**PUBLIC NOTICE  
CITY OF SYRACUSE  
BOARD OF ZONING APPEALS**

**A Use Variance** to allow parking between the front building façade of a future Children Rising Center and adjacent street frontage.  
311 East Taylor Street  
William J. Simmons, Syracuse Housing Authority Owner/Applicant  
MX-2 Zone District

<b>V-24-25</b>	<b>Staff Report – January 16th, 2025</b>				
<b>Application Type:</b>	Use Variance				
<b>Project Address:</b>	311 East Taylor Street (Tax ID: To be determinate by the Onondaga County)				
<b>Summary of Proposed Action:</b>	The applicant is requesting a Use Variance to seek relief from ReZone, Art. 4, Sec. 4.4F(4)c, which prohibits parking areas from being located between the front building façade and adjacent street frontage. If granted, the use variance would allow 16 vehicle parking spaces within the front setback on E Taylor Street. The proposed parking area is proposed to be between the front building façade of the future Children Rising Center and East Taylor Street.				
<b>Owner/Applicant</b>	William J. Simmons, Syracuse Housing Authority Owner/Applicant				
<b>Zoning Violations</b>	The proposed project is seeking a Use Variance to violate the following Z

MATERIALS PLAN

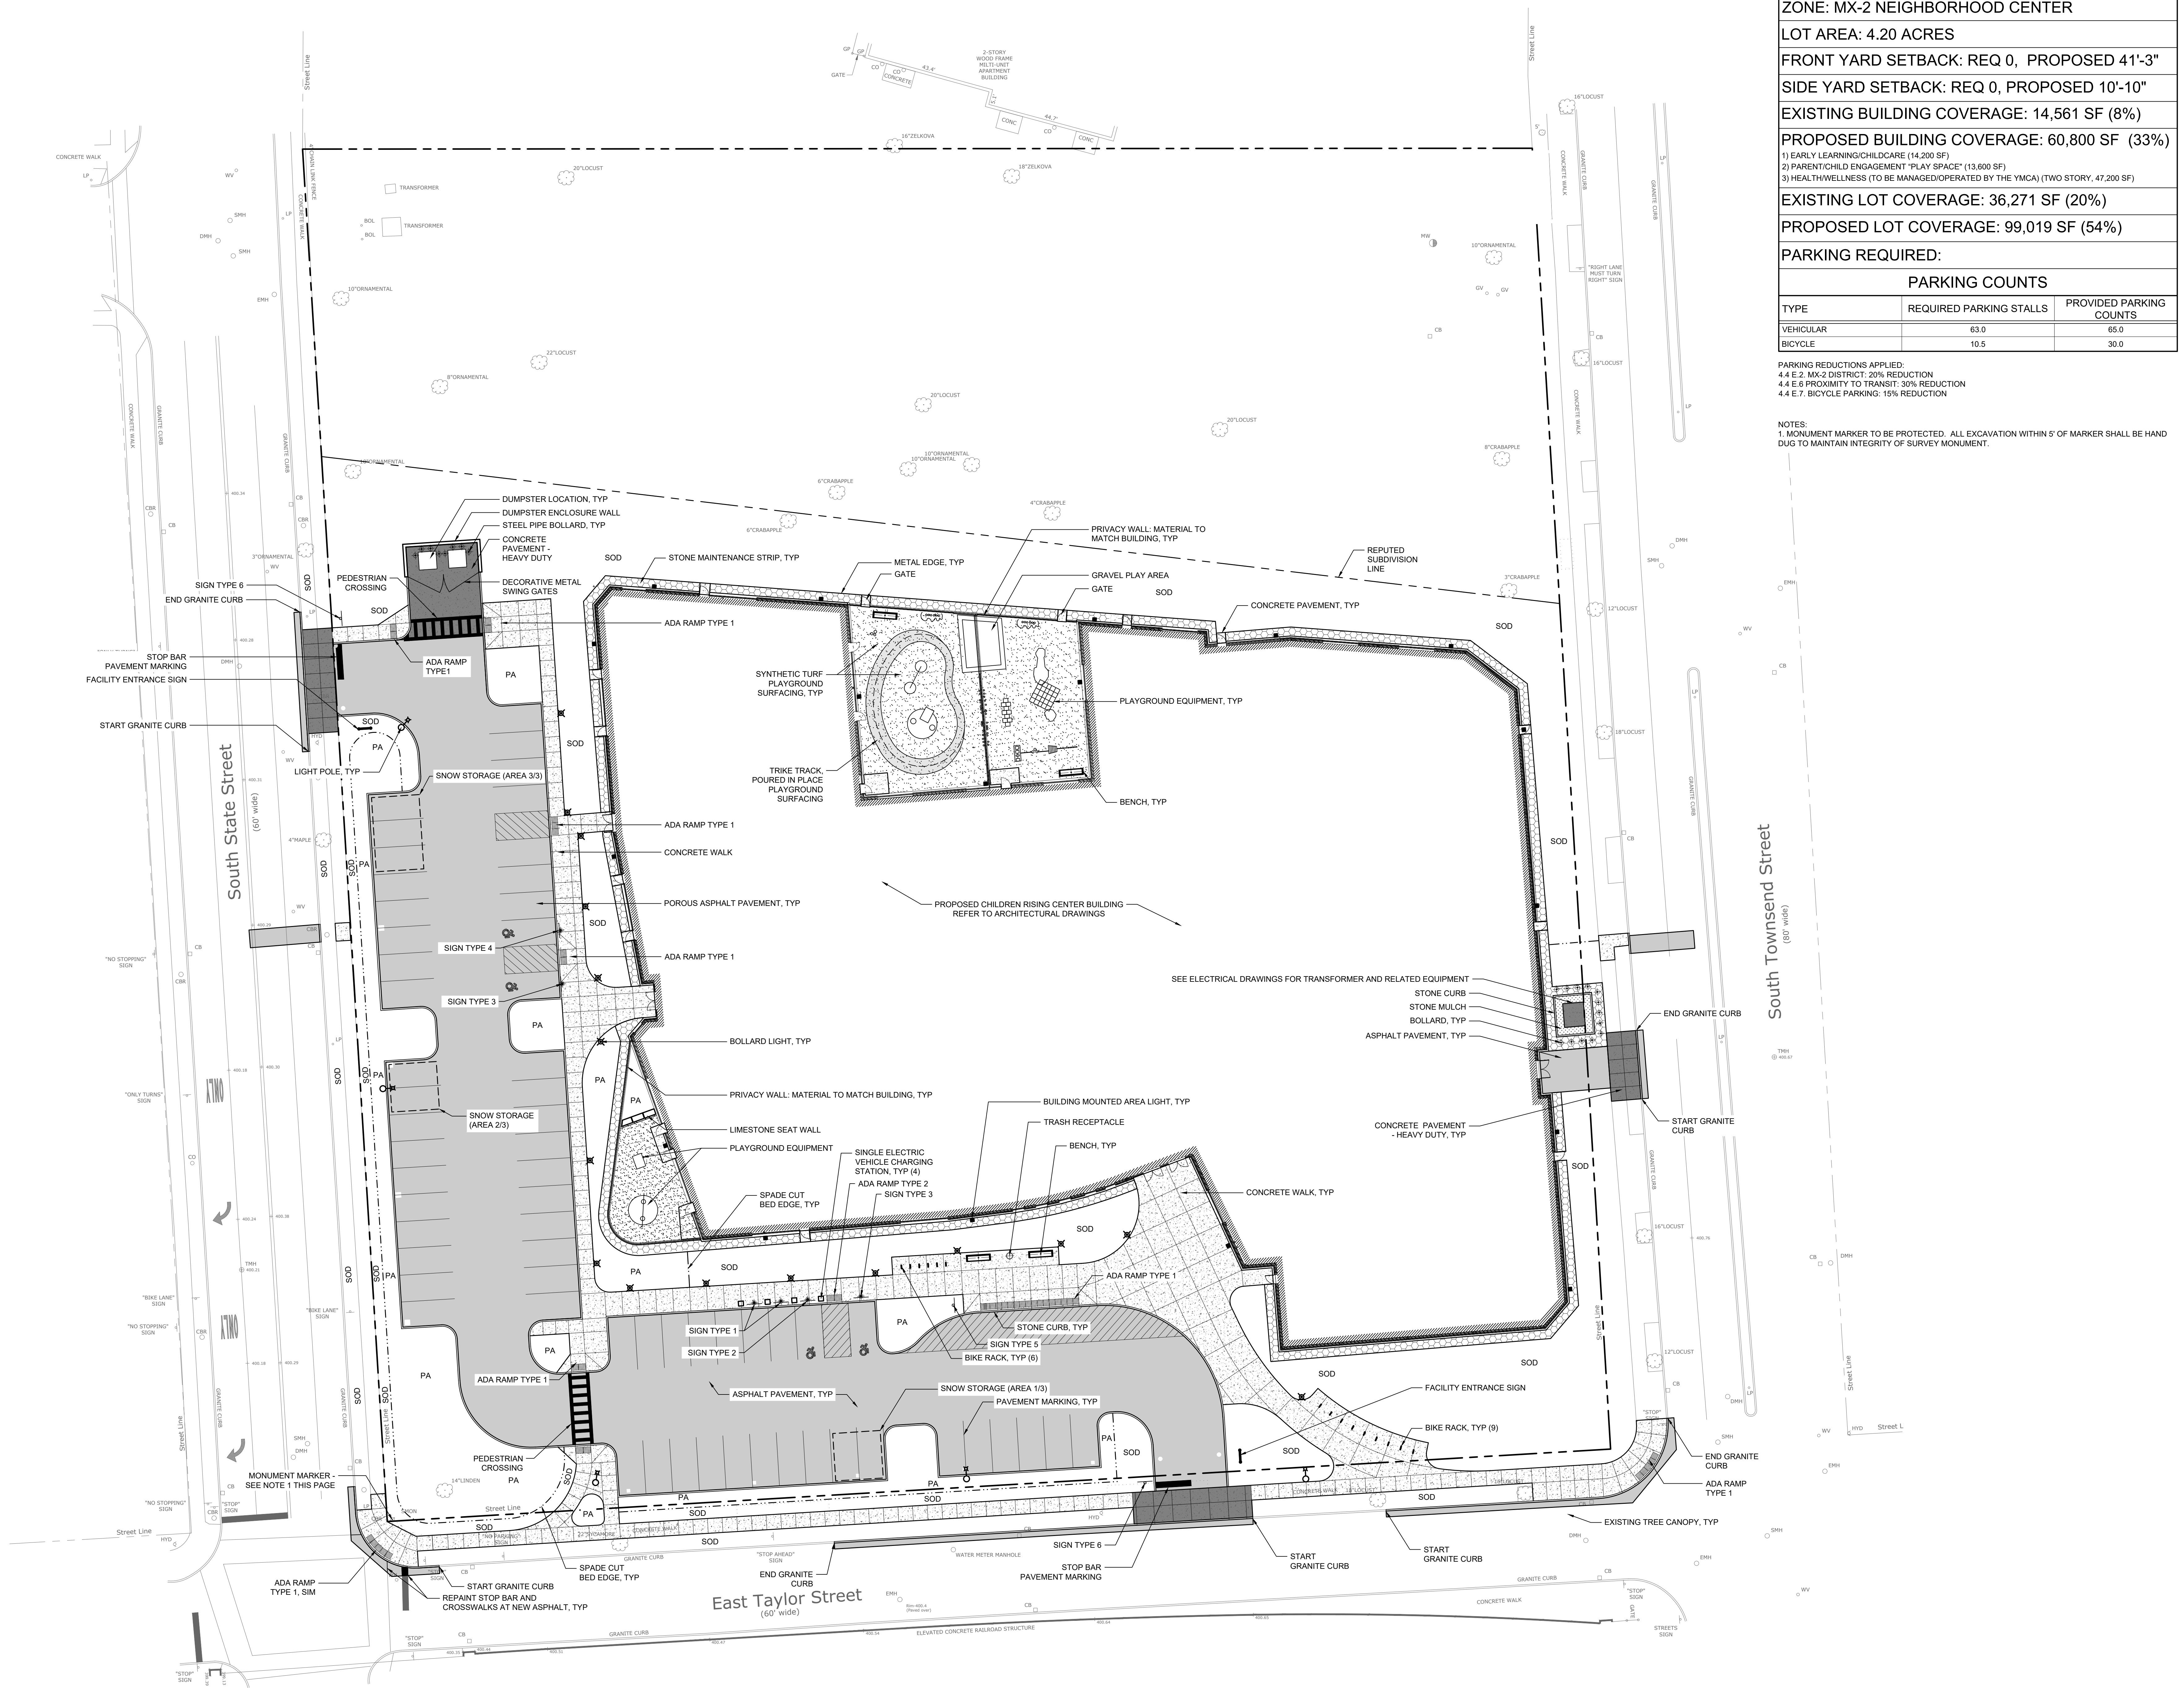
- Curb-cut on Townsend street is not permitted.
- Transformer pad encroaching into the Townsend Street ROW is not permitted.
- Curb-cuts on Taylor and State show 8' transition curb in some areas, which is to be reduced to absolute minimums and turning diagrams supplied. NYSDOT Type-3 entrances.

- Exterior bike parking is to be well-lit and covered.
- Exit isles stop bars to be no less than 3' from edge of walk.
- Planting areas to be on private property and not encroach into the ROW.
